**MONTGOMERY COUNTY HISTORIC PRESERVATION COMMISSION**  
**STAFF REPORT**

<b>Address:</b>	20 West Lenox Street, Chevy Chase	<b>Meeting Date:</b>	3/26/2025
<b>Resource:</b>	Contributing Resource Chevy Chase Village Historic District	<b>Report Date:</b>	3/19/2024
<b>Applicant:</b>	Scott Freedman, Agent	<b>Public Notice:</b>	3/12/2024
<b>Review:</b>	Historic Area Work Permit	<b>Tax Credit:</b>	n/a
<b>Case Number:</b>	1095563 CONTINUED	<b>Staff:</b>	Dan Bruechert
<b>Proposal:</b>	Hardscape Alterations, Installation of In-Ground Pool, and New Fence

## **Tree Preservation Plan – 20 West Lenox Street**

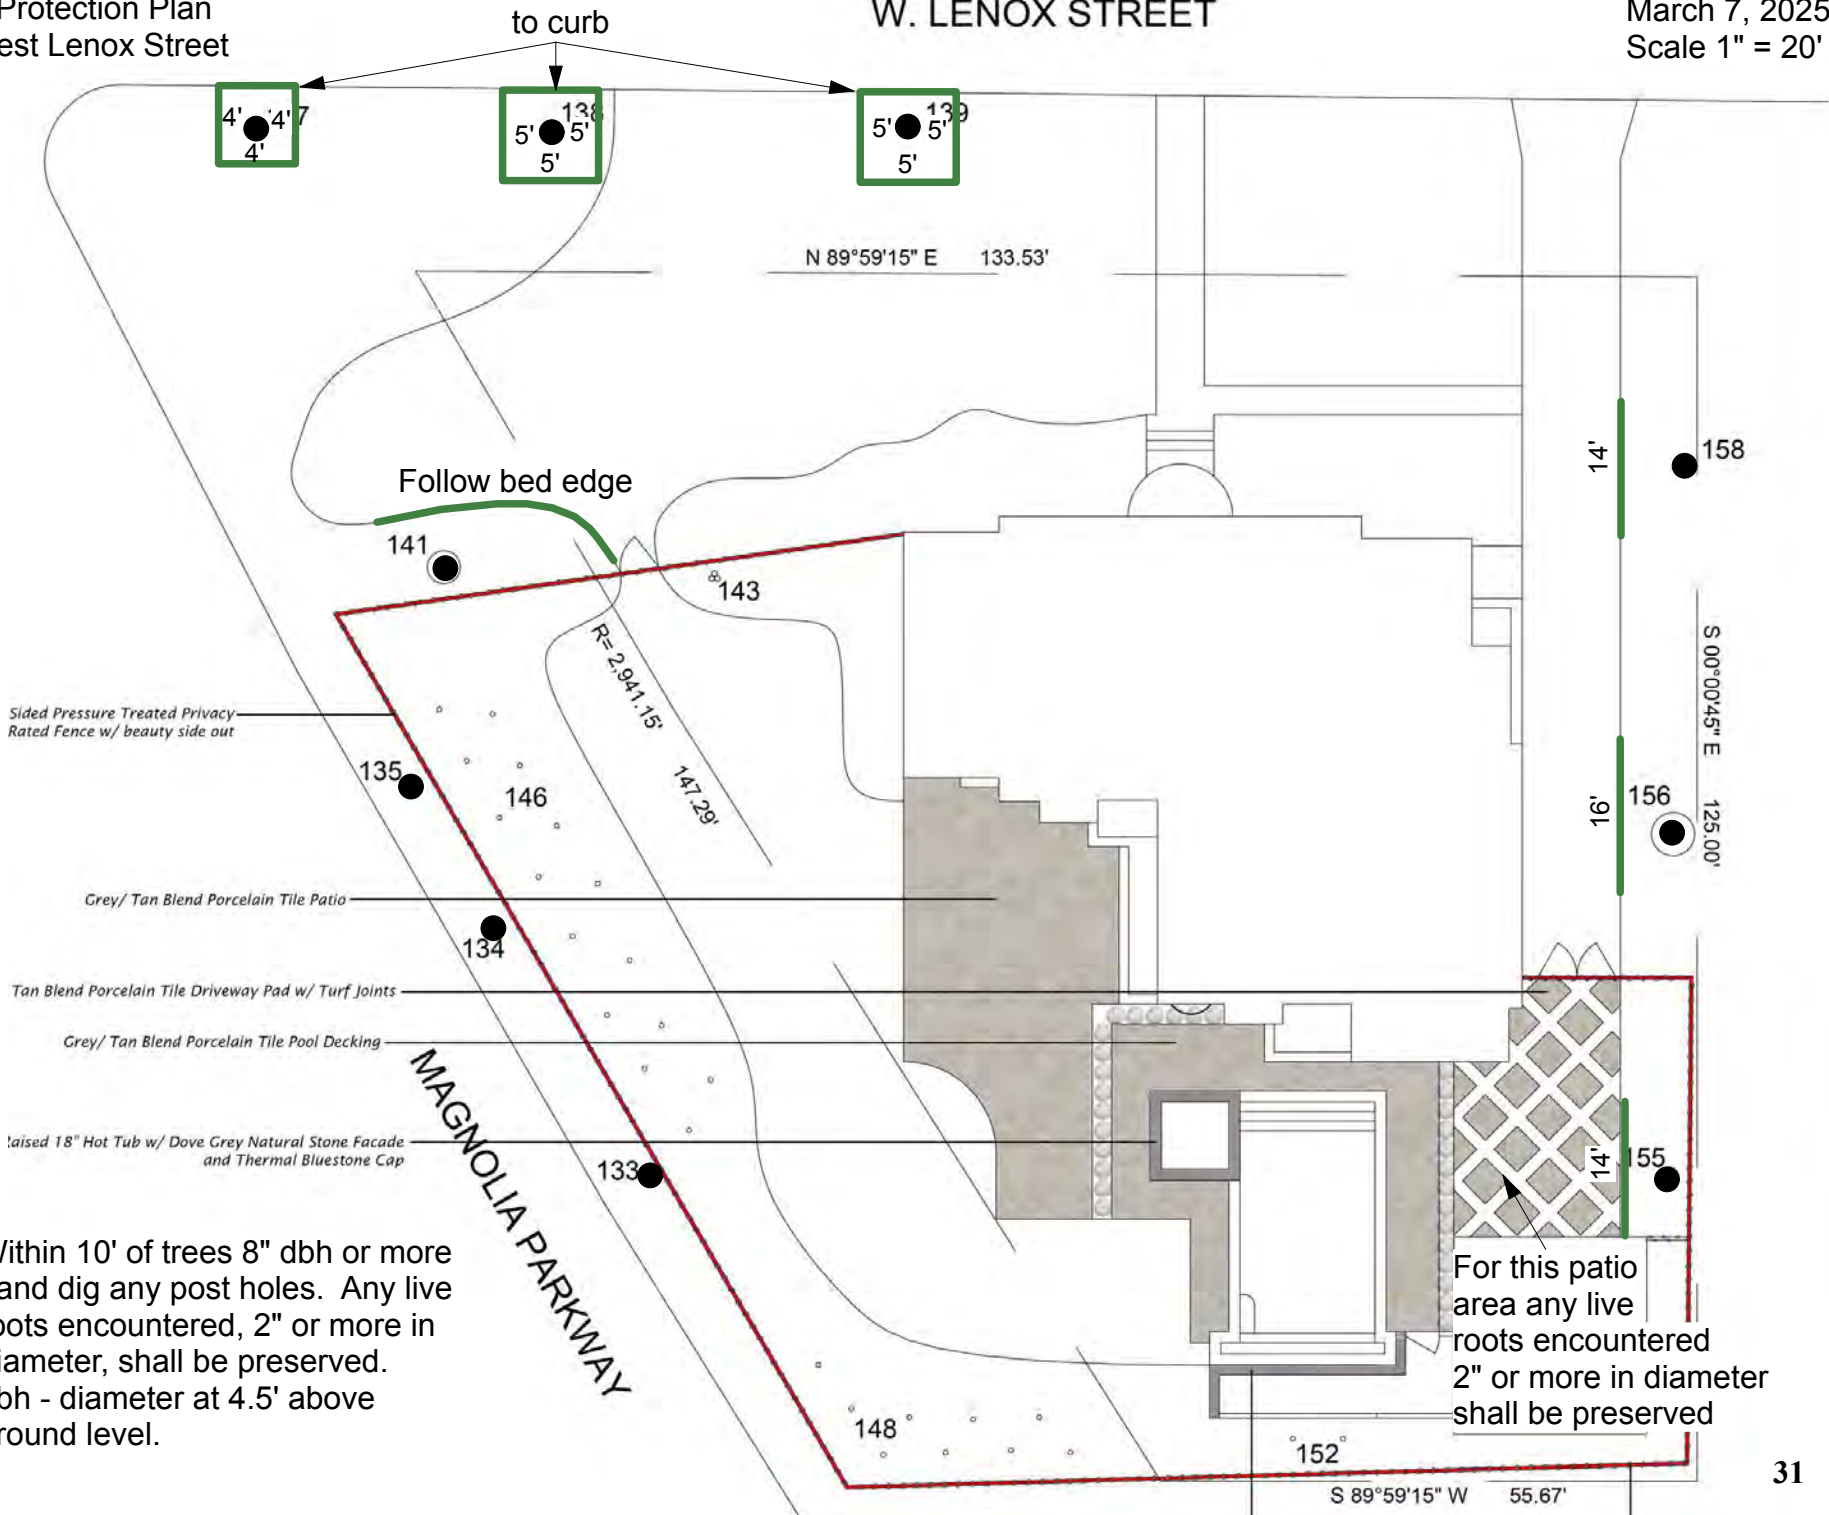
1. Tree preservation fencing shall be installed in the locations shown on the plan. The street tree shall be protected. Tree preservation fencing shall delineate the tree protection zones. Tree preservation fencing shall be 4' tall wire mesh supported with steel stakes no less than 8' apart.

5. No excavation is permitted within the tree preservation areas.
6. The Chevy Chase Village office shall be notified of any construction plan changes.
7. If excavation (outside the tree preservation zone) exposes roots on protected trees, the damaged roots shall be cleanly cut before backfilling the hole.
